Technical information

Theme	Cable connection battery clamp with fuse		
Theme area	Electrical	Telephone	+49 (0)40/ 739 606 – 42
Version	01/2010	Date	04.02.2010

Photo 1:

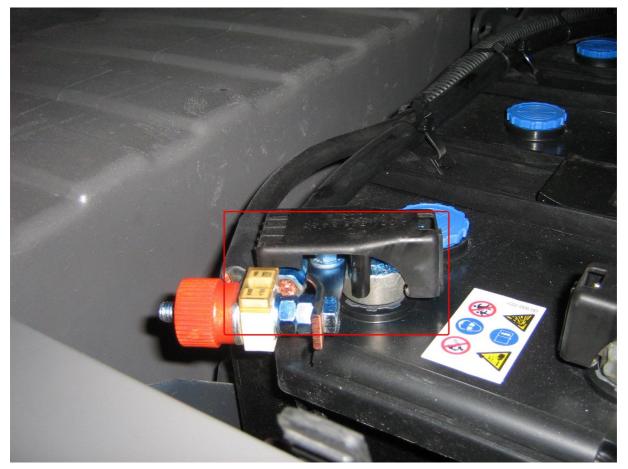
Package content so far: DB Atego battery clamp with tail-lift fuse

Battery cable / tail-lift fuse is not secured enough against splashing water

New package content

For DB Atego trucks, the battery cable is delivered with shrinkwrapped fuse 150 A
